**Assessment Report on
Feasibility of Tree Support Systems proposed in
Study on Stonewall Trees on Slope no. 11SW-A/R577
Bonham Road, Hong Kong**

Highways Department
April 2013

Photo 2.4 – St. Stephen Lane

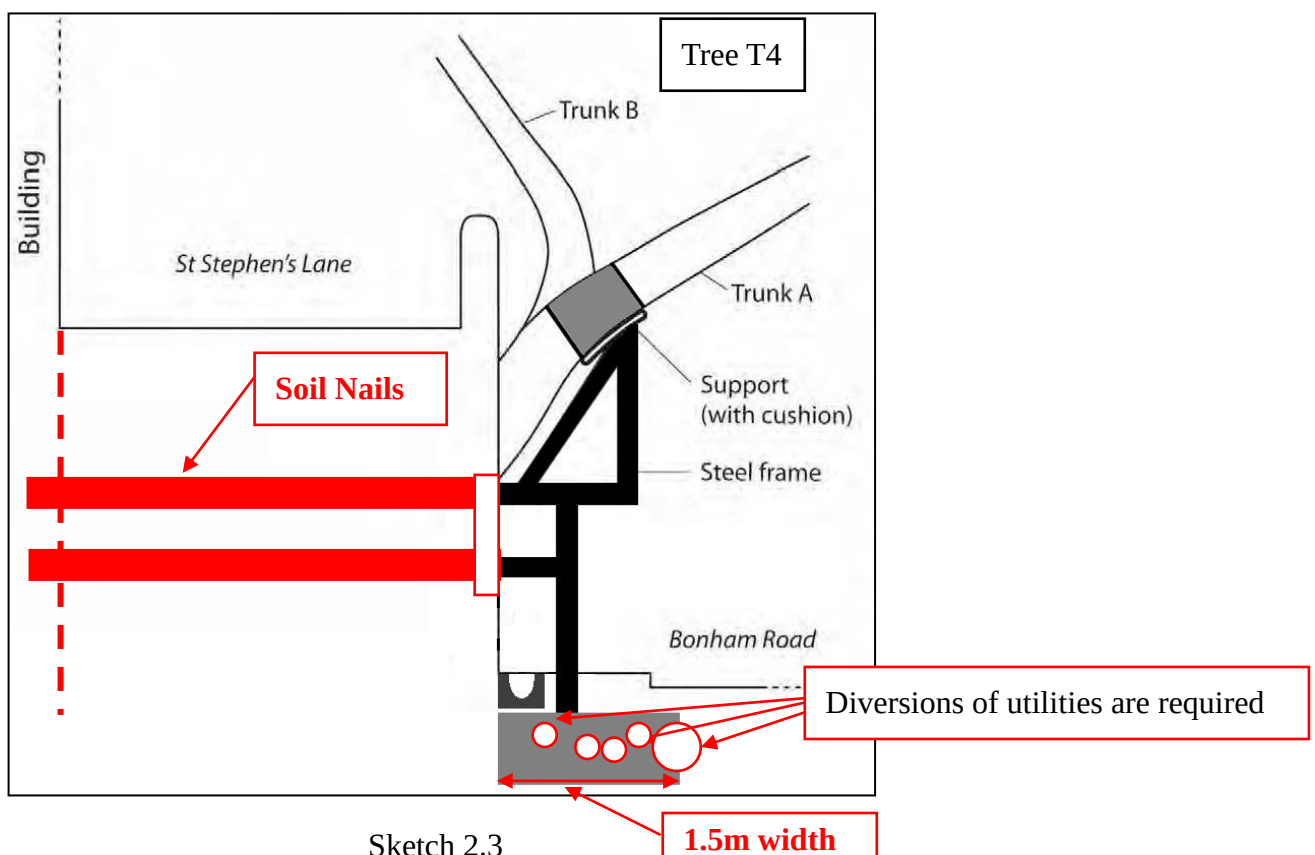
- (i) St. Stephen's Lane is a one-lane two-way carriageway of about 4.5m width, being shared use with pedestrians. The existing road width is not up to current standard due to site constraints. The road width at the location of Tree T4 and T5 are 4.25m and 4.50m respectively. As the absolute minimum carriageway width requirement for a single track access road serving as emergency access² is 3.5m and the horizontal clearance requirements for carriageway to building/structure/obstruction³ is 0.5m on each side, the existing road width is already below or at the minimum standard. It is not viable to install any structures at St. Stephen's Lane due to the road width constraint. (Photo 2.4)

- (ii) The estimated size of the supporting frame would be 0.6m in width perpendicular to the parapet wall. With 0.5m width allowed for erecting a beam barrier to protect the frame and 0.5m clearance from the barrier to edge of carriageway, the structure will occupy 1.6m road width at least. Even the widest section of St. Stephen Lane (about 5m) cannot provide the required road space for the proposed structure because a minimum clear road width of 3.5m as mentioned in (i) above is required.

Photo 2.5 – Southern footpath at Bonham Road (viewing from the east)

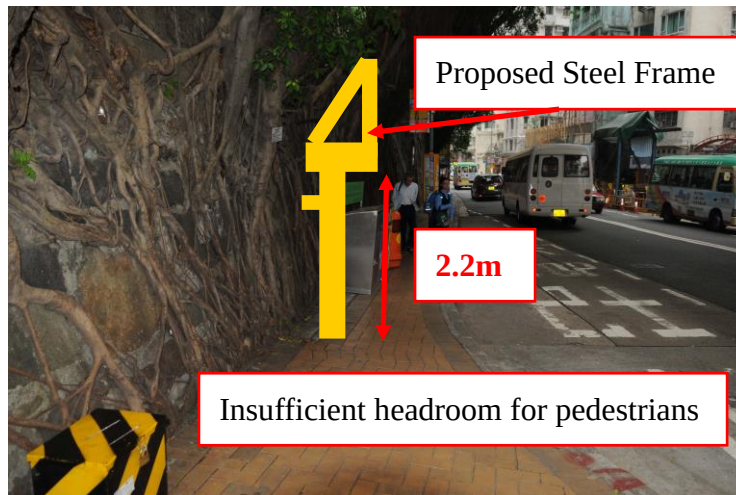
- (i) From our survey, the lower part of the tree is only 2.5m above the existing footpath at Bonham Road. The estimated size of the supporting beams is 0.3m in depth. As such, minimum headroom of 2.3m for footpath cannot be maintained if the supporting frame is to be constructed on the masonry wall adjacent to the footpath. (Photo 2.5)

Sketch 2.4

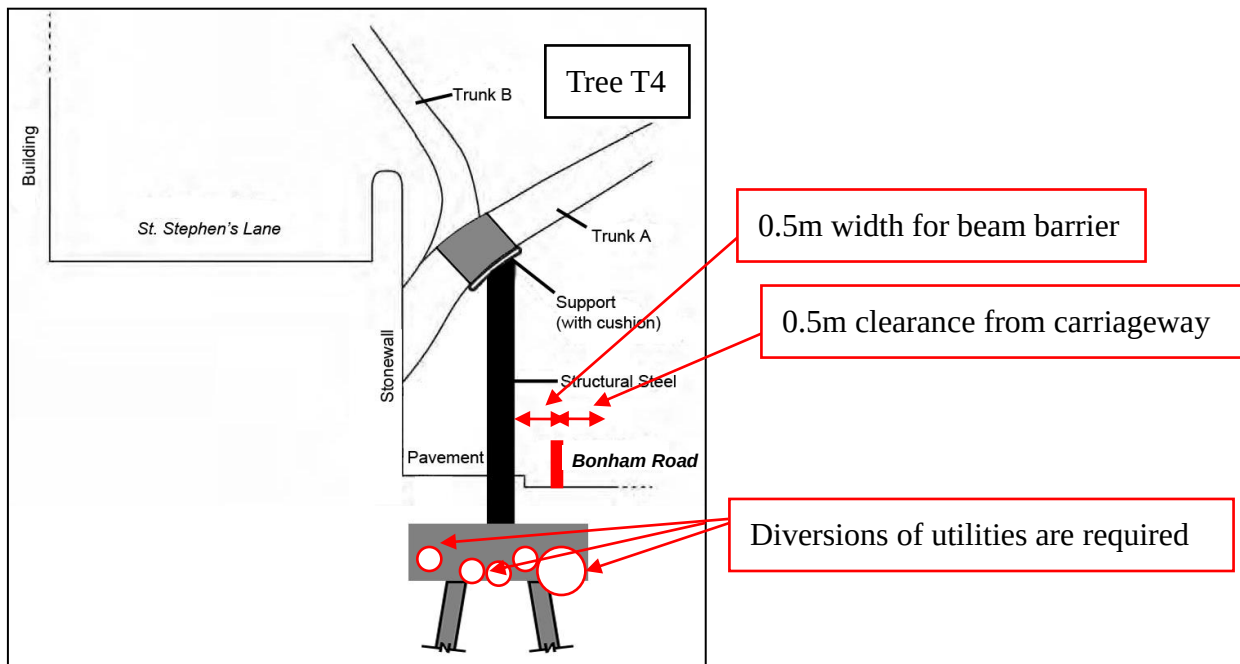
- (i) The estimated size of the anchor plate is 0.4m in width. With 0.5m width allowed for beam barrier to protect the plate and cable and 0.5m clearance from the barrier to edge of carriageway, the structure will occupy 1.4m road width at least. However, as mentioned above, there is insufficient road space at St. Stephen Lane to provide the required road width.

- (ii) Moreover, any transfer of extra loading to the crest of the stonewall will create extra overturning moment and lateral force on the stonewall. Additional stonewall strengthening works will be required. (See also Method B, para. 2.4.1(iii).)

- (iii) Owing to low anchorage point, the overturning moment of the dead load and wind load of the stonewall tree will create a very large tension force on the cables (in the order of 260 tonnes for T4 and 42 tonnes for T5). The foundation of the structure would be in the form of eighteen mini-piles (twelve raking and six vertical piles) at St. Stephen's Lane to

provide the required lateral resistance. The raking piles would hit the foundation of the nearby building and make the scheme infeasible. (See also Method B, para. 2.4.1(iv).)

- (iv) In addition, diversion for underground electric cables at St. Stephen Lane is required. (See also Method B, para. 2.4.1(v).)

Photo 2.6 – Southern footpath at Bonham Road (viewing from the west)

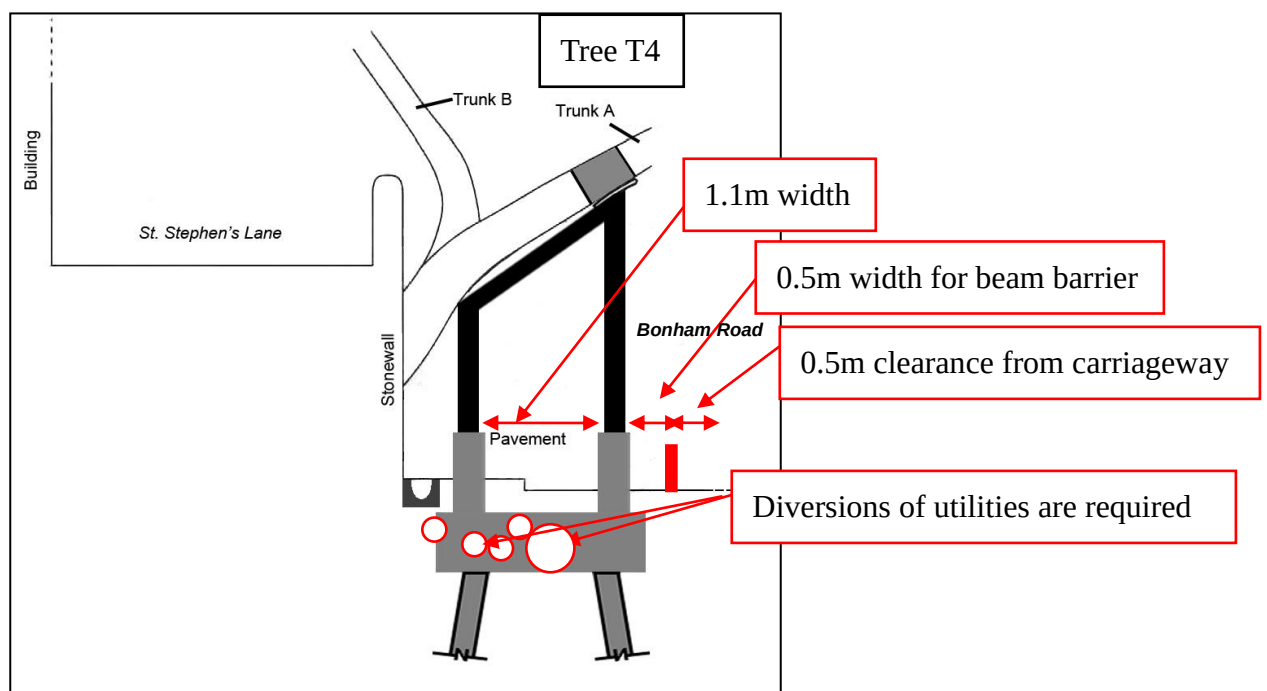
- (i) The existing footpath width near tree T4 and T5 is only 1.23m (Photo 2.6) which is not up to current standard. It is already too narrow to accommodate both pedestrians and passengers waiting at the bus stop. The construction of structures occupying extra footpath spaces is therefore impractical.

- (ii) Relocation of bus stop and cancellation of bus lay-by to free more space for the proposed works has also been considered but impractical. (See also Method C, para. 2.5.1(iv).)

- (iii) Large supporting moment (in the order of 2300KNm for T4 and 360KNm for T5) to support or stabilise the trees by the steel pole and foundation is required to counterbalance the bending moment induced from the dead weight of the tree and wind loads acting on the tree. The foundation of the steel structure in the form of four raking mini-piles is required. The pile cap size will be in the size of 2.5m x 2.5m. Diversions of utilities at

Photo 2.7 – Northern footpath at Bonham Road

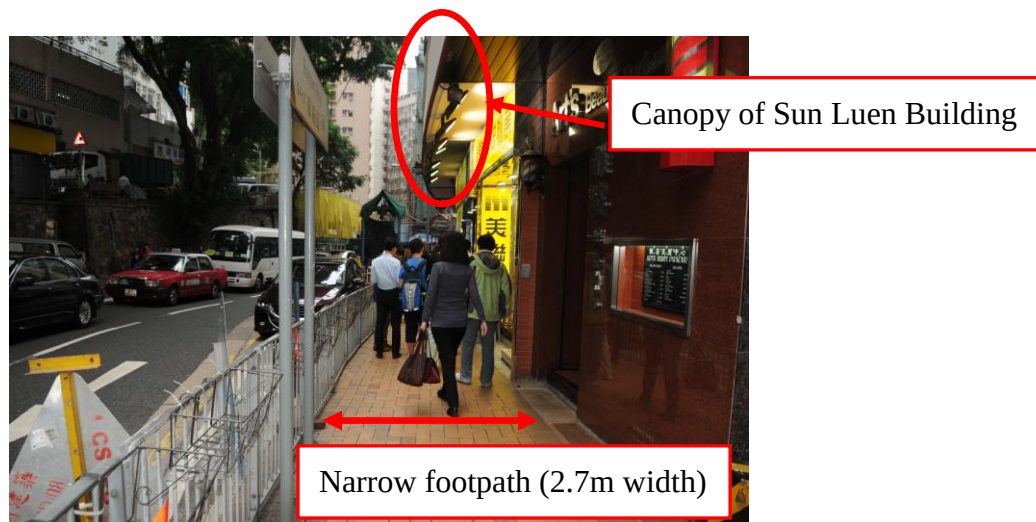
- (ii) The footpath at the opposite side is 2.7m wide only. In addition, the existing canopy of Sun Luen Building will obstruct the steel structure (Photo 2.7). With the 0.5m clearance requirement from the carriageway and 0.5m width for beam barrier, there is insufficient footpath space to accommodate the massive structure steel post (about 1m width steel post).
